# Intel<sup>®</sup> 81341 and 81342 I/O Processors

Specification Update

*November 2008*

Order Number: 315042-008US

**Figure 8. VCC1P2PLLS0, VCC1P2PLLS1 Low-Pass Filter**

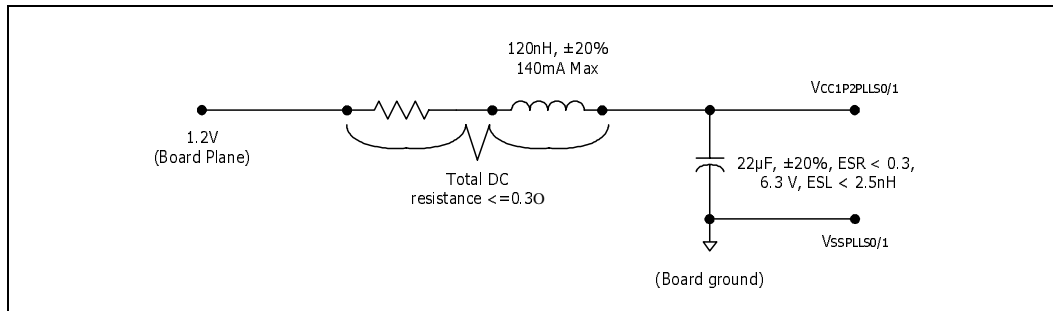
**Problem:** The VCCPLL Pin Requirements section of the Datasheet have changed. See below for the updates in Section 4.1 and Figure 8 in the Datasheet.

This paragraph pertains to the VCC1P2PLLS0, VCC1P2PLLS1 filters. The recommended filter for the PLL supplies is shown in Figure 8. The purpose of this filter is to achieve at least 10 dB rejection of frequencies between 1 and 20 MHz. The board supply distribution system must ensure that the minimum voltage into the PLL ball is equal to or greater than 1.164 V. The current draw for the IC is 95 mA typical less than 140 mA maximum. The filter components are selected to achieve a corner frequency of 100 KHz. The series resistance keeps the Q of this resonant circuit safely below unity for all component variations. The total DC resistance of the resistor and the inductor must be equal to or less than 0.3 Ohms.

The bypass capacitor must be placed as close to the supply pins as possible. The series impedances to both the supply pin and the PCB analog ground plane must be an order of magnitude lower than the ESR and ESL specified for the capacitor. The S0/S1 PLLs have dedicated internal supplies, so the VSSPLLS0/S1 pins must be soldered directly to the analog ground plane of the PCB.

**New Figure 8:**
